Anacortes City Council
Municipal Building Council Chambers
**** This meeting will be held electronically only ****

October 5, 2020
6:00 p.m.

File Number:	CUP-2020-0001
Project Name:	1015 18 th St. Parking Lot CUP
Proposal Description:	New private parking lot located partially within the R4 zone and Commercial Zone.
Documents available at:	City Hall, Planning Community & Economic Development Department
Public hearing:	Anacortes Planning Commission
Public hearing date:	September 23, 2020
PC deliberations:	September 23, 2020
Decision Body:	Anacortes City Council
Closed Record Hearing Date:	October 5, 2020 @ 6:00 PM

Re: REVISED Conditional Use Permit (CUP-2020-0001) Narrative for 1015 18th St. Parking Lot;
P55166; PRE-2019-0028

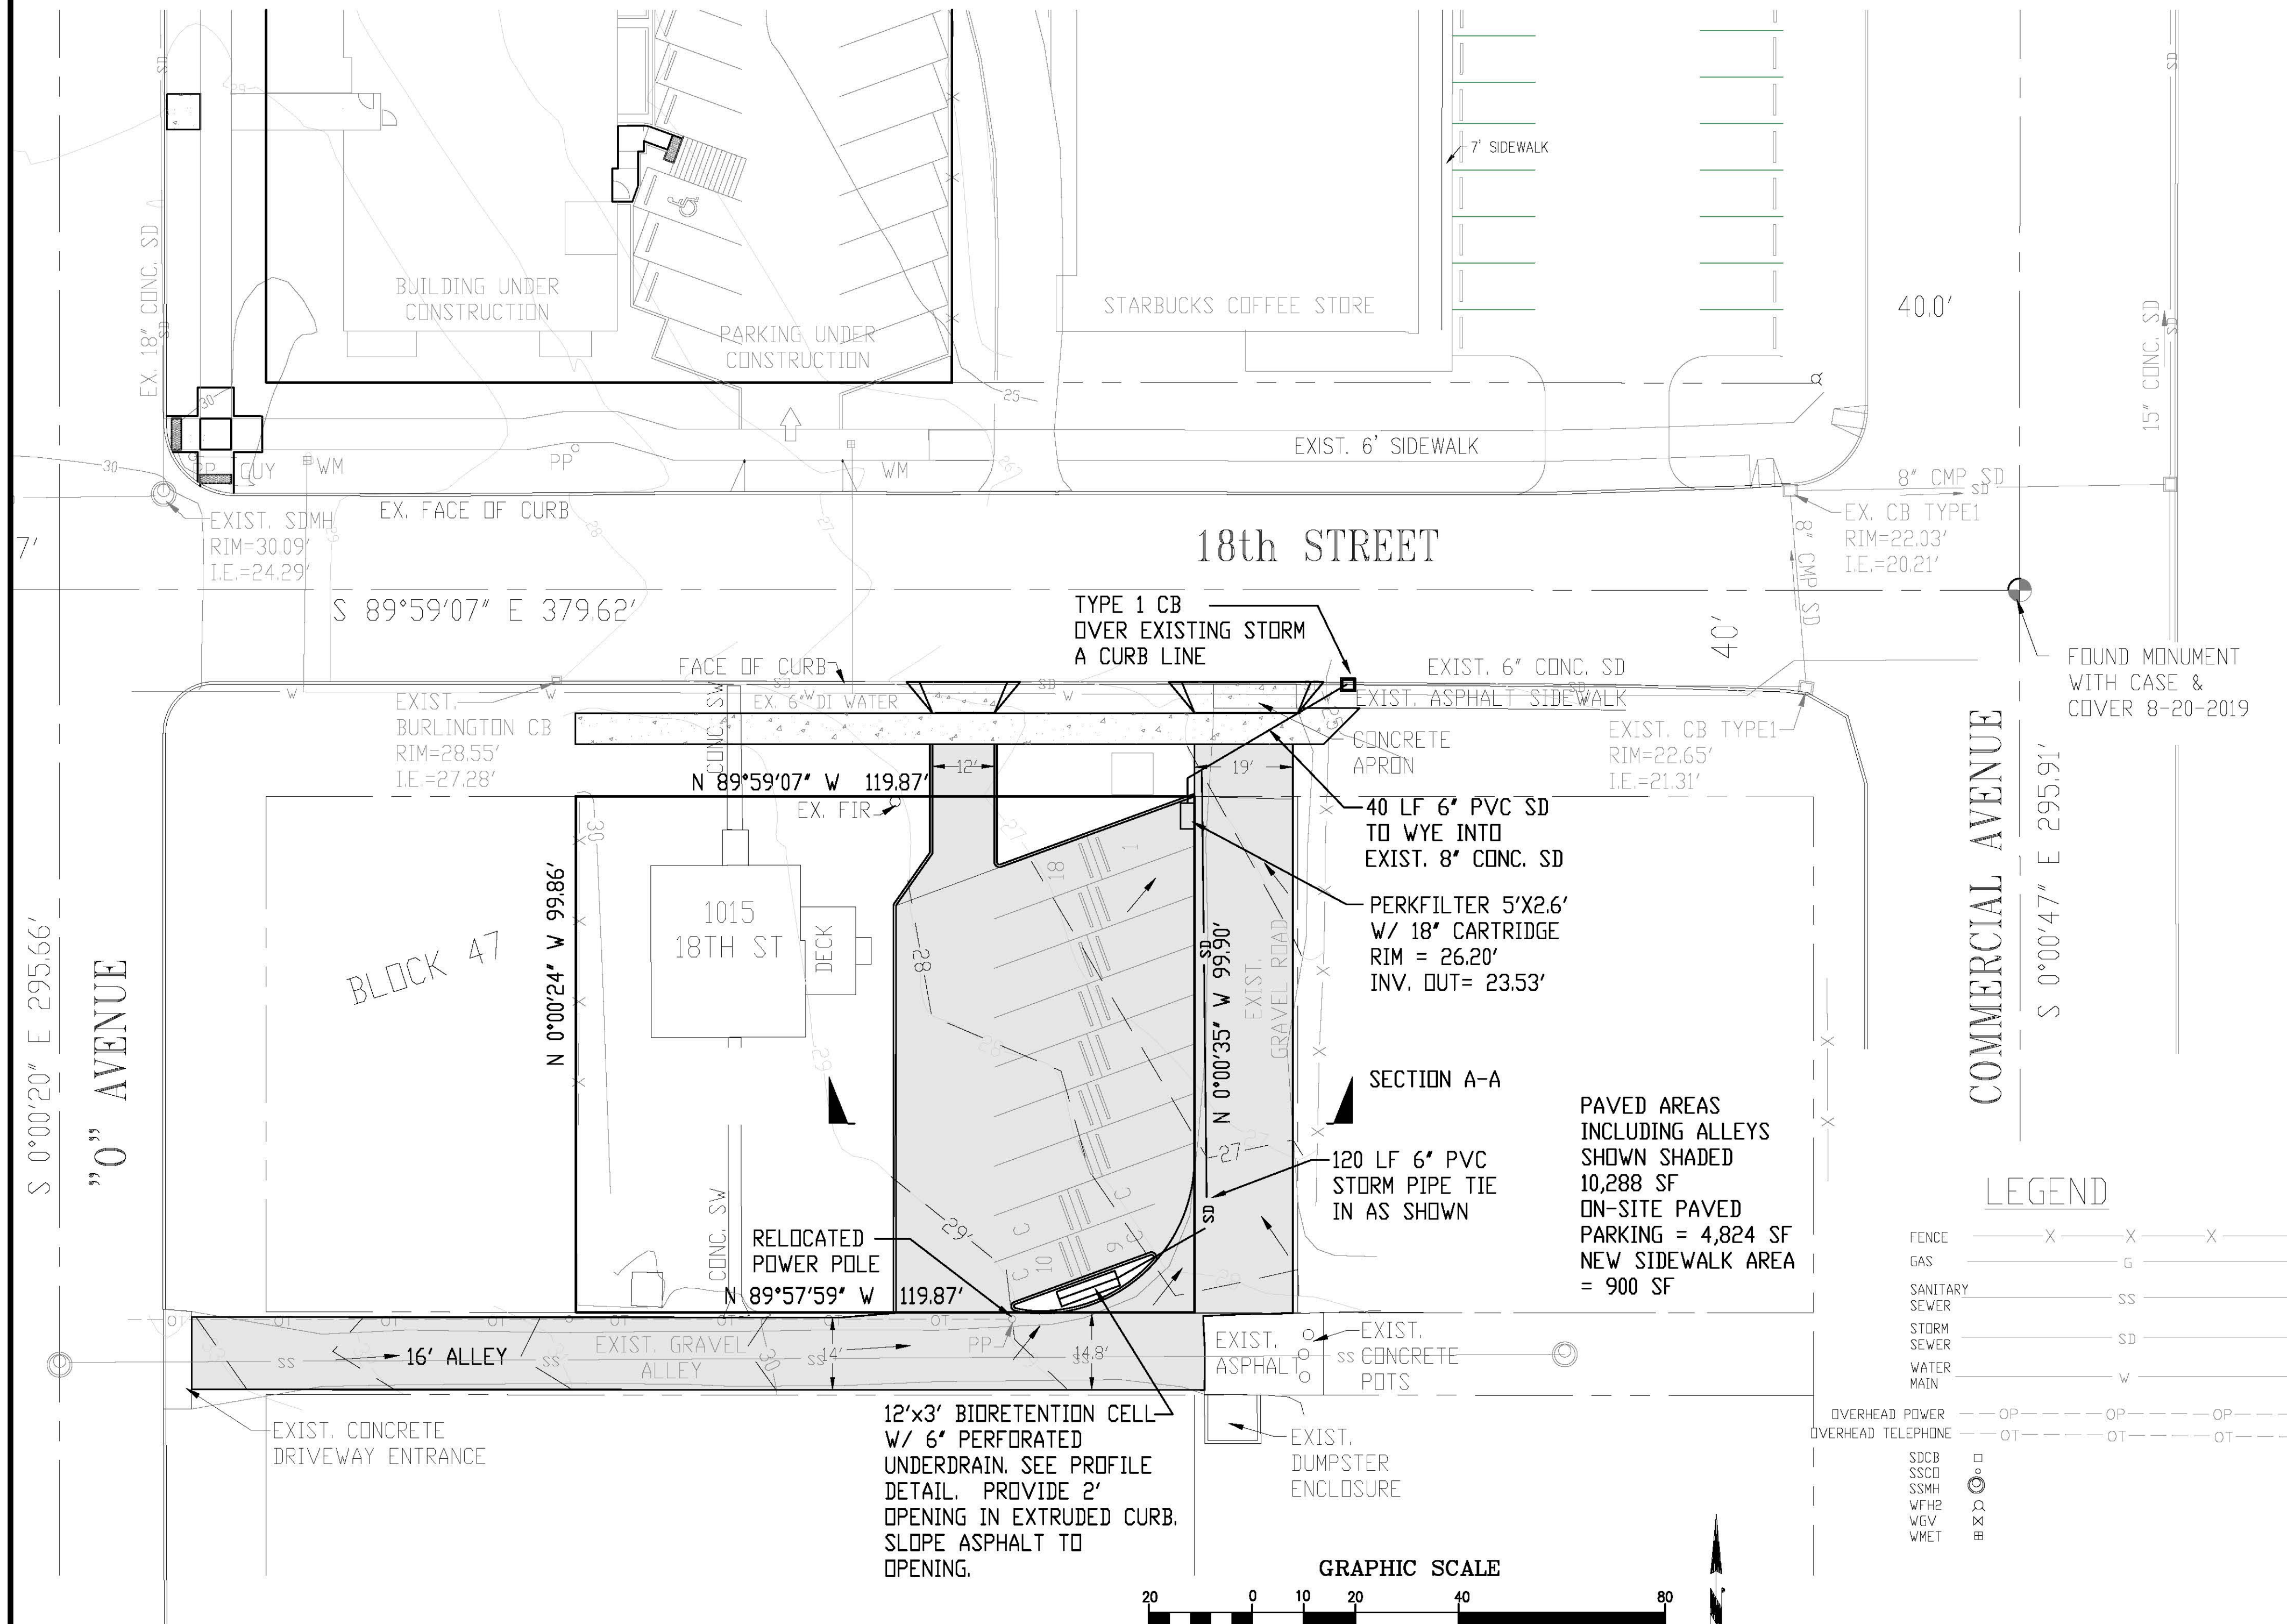
1. The runoff treatment analysis states that it will consider only the new pollution-generating impervious surface within the private property and not in the public right-of-way. This includes an area of approximately 7,800 square feet. The total new and replaced pollution-generating impervious surface is listed on Sheet C4 as 10,288 square feet. Since the alley is going from gravel to paved, it is considered new impervious surface. All new pollution-generating surfaces should be included in the runoff treatment analysis and the PerkFilter shall be sized accordingly.

1. The runoff treatment analysis states that it will consider only the new pollution-generating impervious surface within the private property and not in the public right-of-way. This includes an area of approximately 7,800 square feet. The total new and replaced pollution-generating impervious surface is listed on Sheet C4 as 10,288 square feet. Since the

1. The runoff treatment analysis states that it will consider only the new pollution-generating impervious surface within the private property and not in the public right-of-way. This includes an area of approximately 7,800 square feet. The total new and replaced pollution-generating impervious surface is listed on Sheet C4 as 10,288 square feet. Since the
